Firmware change-log of new features and bug fixes of the u-remote IO-Modules:

Firmware updating Information:

UR20-1SM-50W-6DI2DO-P (2489830000)

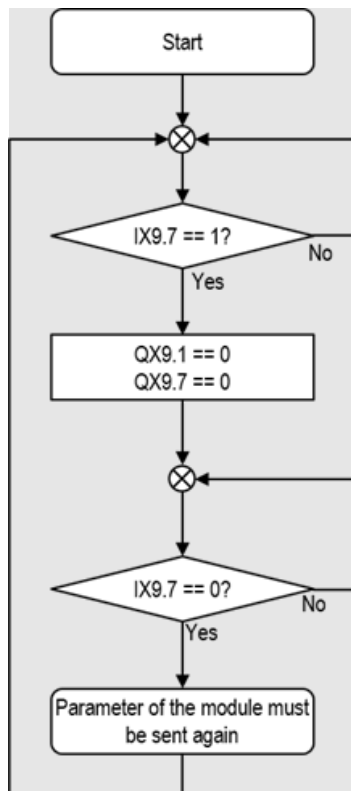
• **Known issue:**

Non-simultaneous power cycling of external power supply and u-remote system supply while a motor is rotating could lead to unwanted motor movement:

- A power cycle at the external power supply while the u-remote system supply remains causes the motor to stop and restart after external power supply is restored. The motor will continue moving to the target position of the last move command before the power interruption.
- A power interruption of the u-remote system supply while the external power supply remains causes the motor to continue to rotate to the target position of the last move command.

• **Workaround:**

The application program of the connected controller (PLC) should check the status of the process data bit "State power supply" (IX9.7). If the "State power supply" bit is "false" (0) the program should reset both the bit "Moving" (QX9.1) and the bit "Enable motor driver" (QX9.7) to "false" (0). (please see UR20 Stepper motor module manual)

- This behaviour is planned to be fixed with the next firmware update.
